FIELD SERVICE BULLETIN

FSB Number: LVCCFSB2006-31
Author: Ross Karlen
Date: February 1, 2006
Total No. of Pages: 3
Subject: **3G E1070, E770v, V3x – Headset Not Recognized**
Model Affected: Friwo Charger SPN5202A and SPN5202B
Level of Repair: 1

FIG 1.

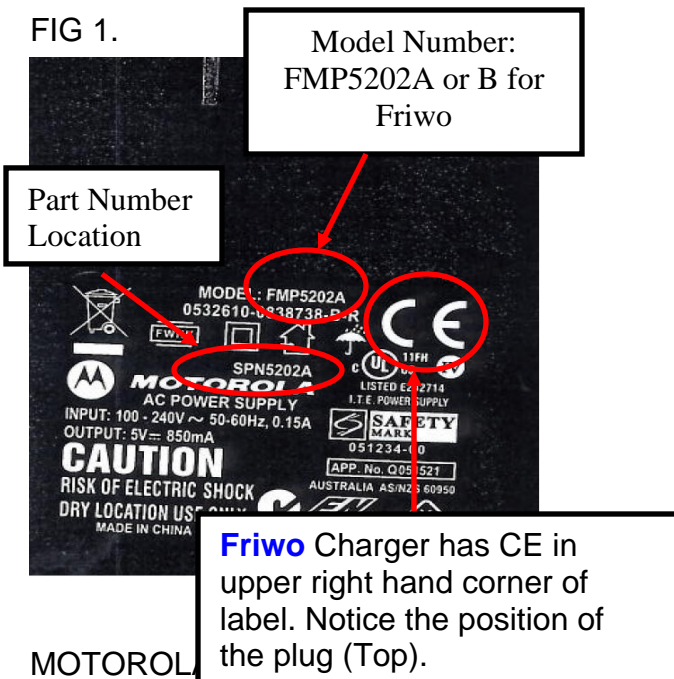
Service is aware of an issue, highlighted by the carrier on V3x. During initial testing it was found that under certain conditions the Audio Headset would not be recognized when plugging into the USB port on the phone. Analysis revealed the issue to be linked to the state of the ID on Friwo Chargers (SPN5202A and SPN5202B see FIG1) as read by the SW on charger insertion. The state of the ID pin read is not consistent since it has not reached a stable value prior to being read by SW. Sometimes it is floating and sometimes it is grounded, but neither of these states is correct. If the state is read as floating, the headset would work on subsequent insertion. If the state of the read is grounded, then the headset will not work. This issue only occurs with the Friwo charger, not with the Phihong charger.

Short Term: Friwo chargers (FIG 1. SPN5202A and SPN5202B) are quarantined, started shipping with Phihong charger (FIG 2. SPN5202A). NOTE: Need to identify by location of the CE on the charger label.

Note: If software approved in your region is not later than the software with the fix, you must verify the customer's charger is a Friwo Charger (SPN5202A/SPN5202B) and replace it with a Phihong charger (SPN5052A). See images above for identification.

Do not use Friwo chargers (SPN5052A and SPN5052B) as replacements on the models listed above. Please replace with Phihong chargers (SPN5052A). Please see images above on how to determine the difference between the vendors as the part numbers are the same.
